### **REMARKS/ARGUMENTS**

**AMENDMENTS TO THE DRAWINGS:**

Figure 3.1 - Z2002A Software Block Diagram

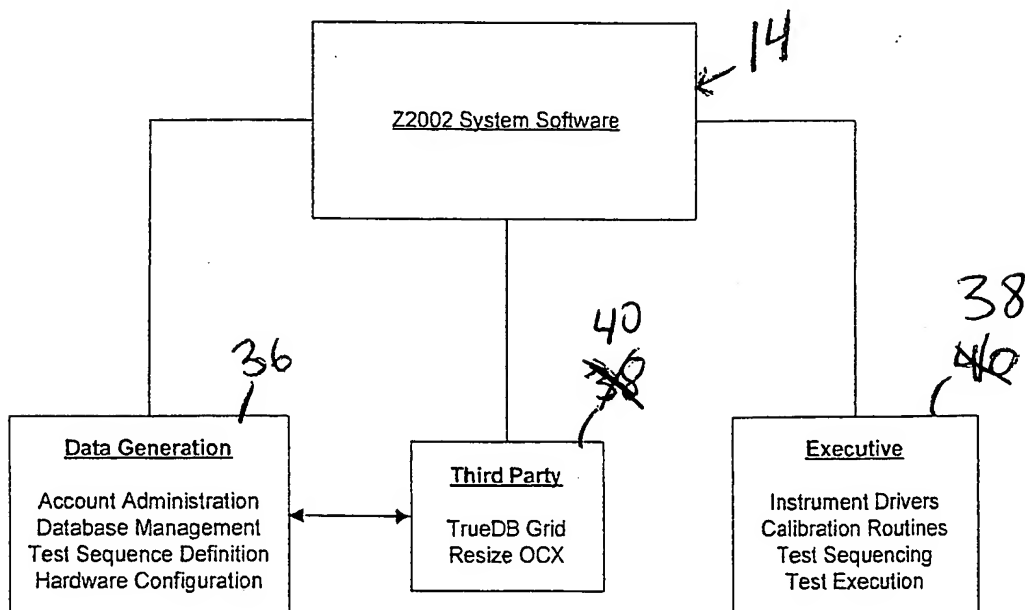
In response to the objections to the specification and drawings, proposed revised Figs. 3.1 and 3.2 are submitted herewith in which the executive software is labeled consistently with reference numeral 38 and the third party software is labeled consistently with reference numeral 40.

The attached sheets of drawings include changes to Fig. 3.1 and 3.2. The sheet which includes Figs. 1 and 3.1 replaces the original sheet including Figs. 1 and 3.1 and the sheet including Fig. 3.2 replaces the original sheet including Fig. 3.2. In Fig. 3.1, the designation of the executive software is changed from “40” to “38” and the designation of the third party software is changed from “38” to “40”. In Fig. 3.2, the designation of the executive software is changed from “40” to “38”.
